**Lincoln County  
Land Use Office  
P.O. Box 39  
Hugo, Colorado 80821**

Re: TR Adequacy Reviews

**Re: Raymond Enderson Pit, Permit No. M-2000-066, Technical Revision No. 4 (TR-04)  
Adequacy Review-01**

# MINING MAP

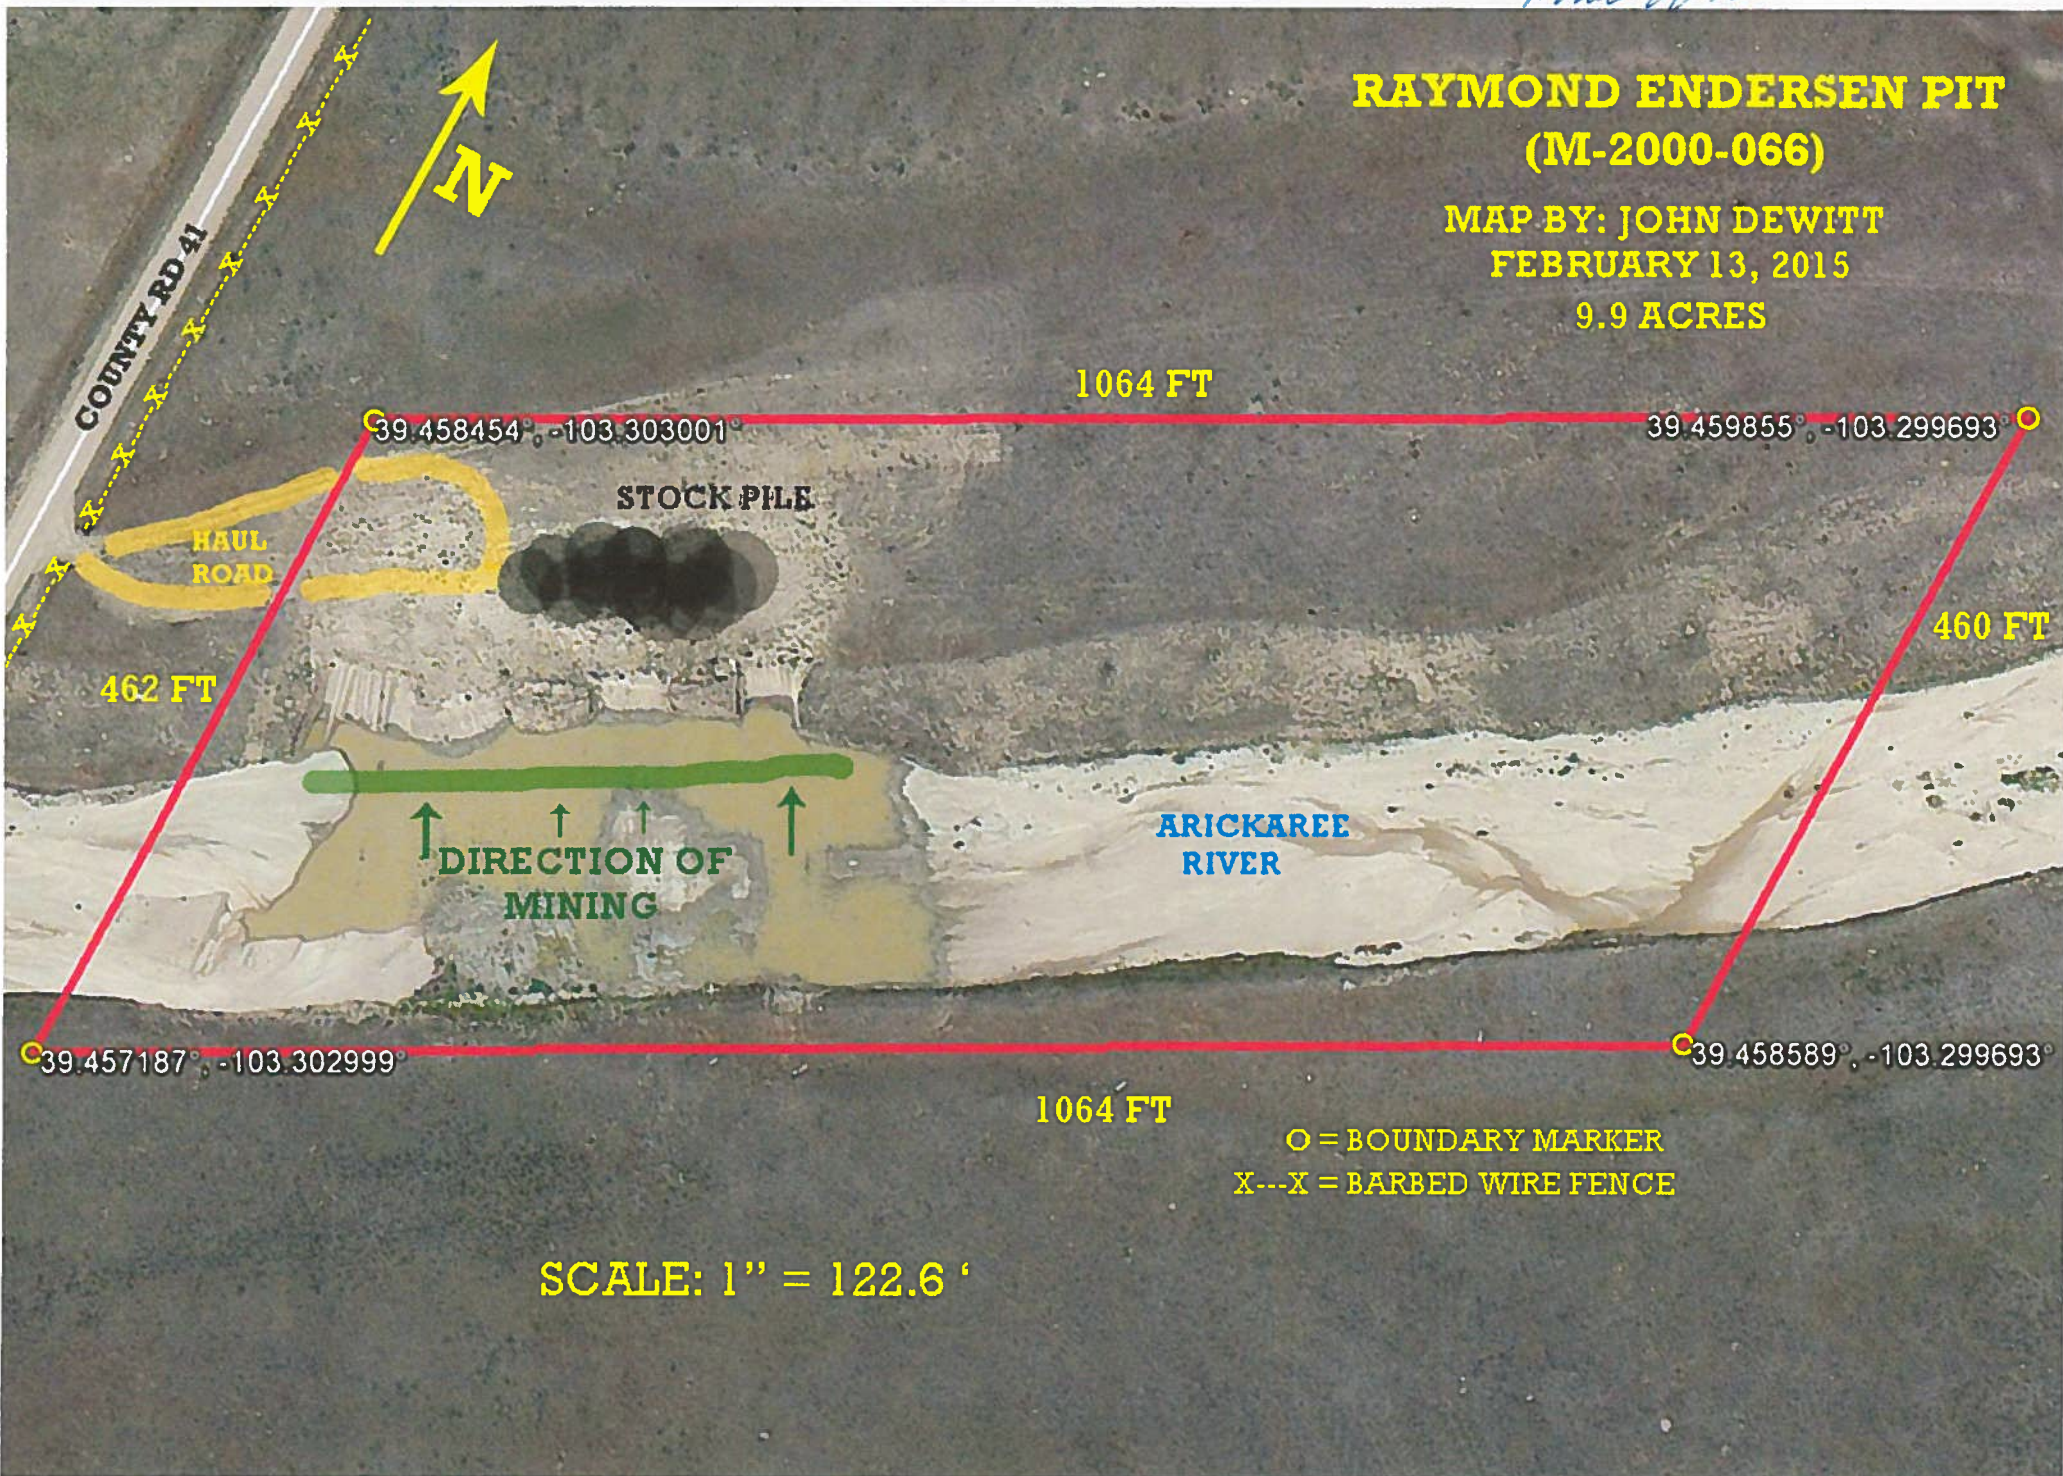
1) The original Mining Plan Map submitted with the 110c application that was approved on June 27, 2000 shows a 200 ft mining setback from the Co Rd 41 ROW (see enclosed map). If this is a required setback, please add it to the revised Mining Plan Map. In addition, because the western permit boundary appears to be approximately 60 ft from the ROW, the 200 ft setback should be marked on site to help keep mining activities within the permit area at the appropriate setback distance.

There is no required setback from CR 41 that I am aware of, neither for regulatory reasons or by directive of the Landowner. The distance of the Western boundary from the road in this revision, was not changed from the original distance. Likely, the former Land Use Administrator simply denoted on the map that the pit boundary was *supposed* to be 200 ft from the road, but it was improperly staked. Errors like this are what is responsible for the exhaustive efforts in identifying, revising, and correcting the pit maps and boundaries. Please accept the revised version of the map of this site as being the corrected version. The boundary markers were determined and stake using a Trimble GEO XT 3000 sub-meter GPS device. Google Earth Pro polygon / acreage calculation function was used for the acreage calculation. (Both techniques have, and will be used for all past and future staking / acreage data submitted)
